17-097MSP – PENZONE SALON

Request

Approval of a Master Sign Plan (MSP) for the 12,000-square-foot Charles Penzone Grand Salon and existing salon on a 1.8-acre parcel.

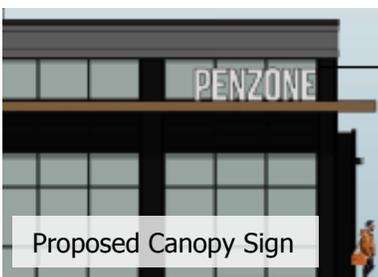
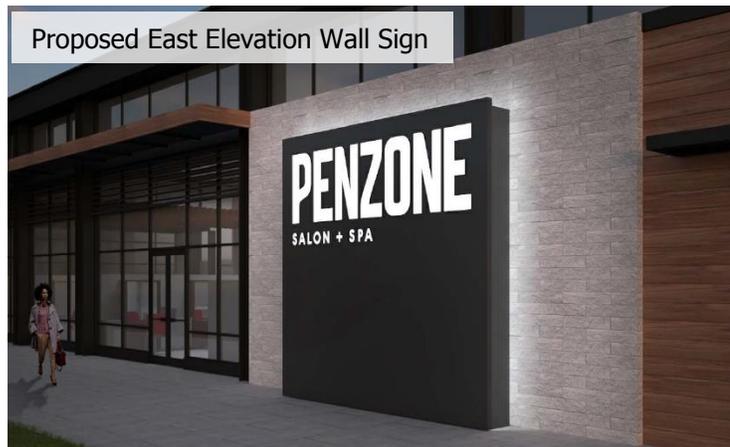
The second wall sign on the east elevation is proposed as a ±66-square-foot sign with channel-cut, back lit letters mounted on a 230-square-foot black metal panel cabinet which is lit around the edges. The letters are mounted 12-feet from grade within the panel. The metal cabinet is 14'4" from grade to top of cabinet. The metal cabinet will conceal gas meter mechanical equipment and the illumination light source equipment. A hinged access for the gas meter is located at the lower right corner of the cabinet and is approximately 37 square feet in size and designed of the same material.

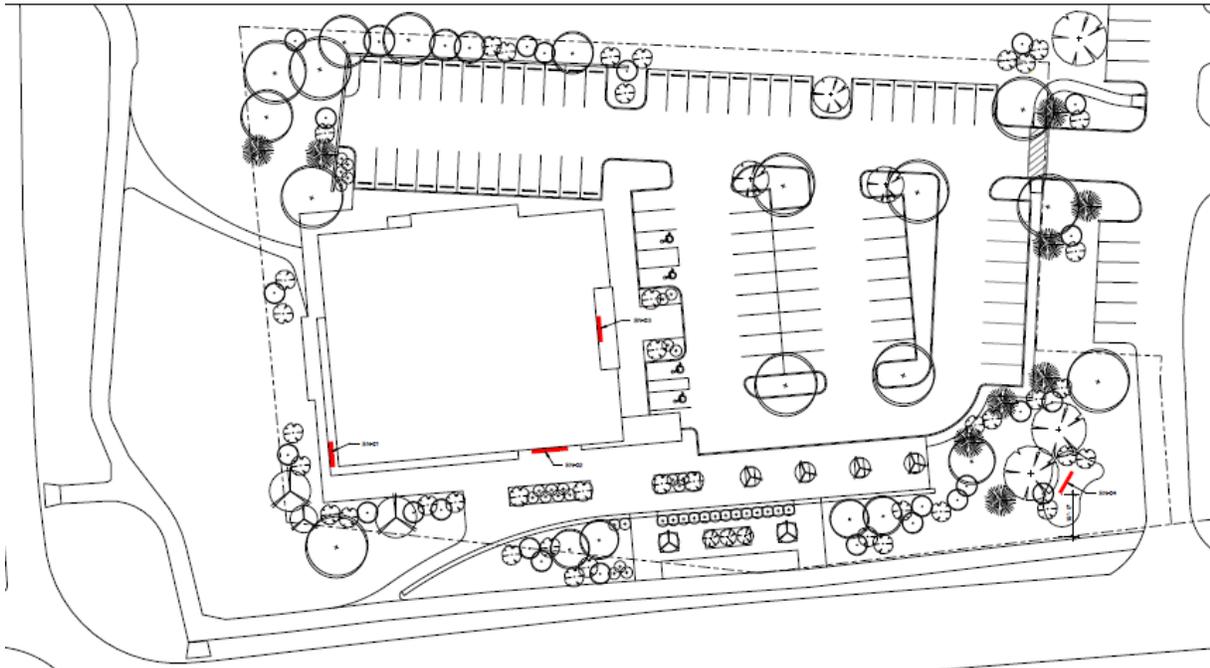
The sign plan defines a new sign type, a Canopy Edge Sign, which is similar to other signs designated as this type in the Bridge Street District Master Sign Plans. This sign would be a ±34-square-foot internally lit

individual white channel letters with black returns mounted vertically on top of the shade structure. It is proposed to be at a height of 20 feet from grade to the top of the sign. The individual letters will be 3 feet tall.
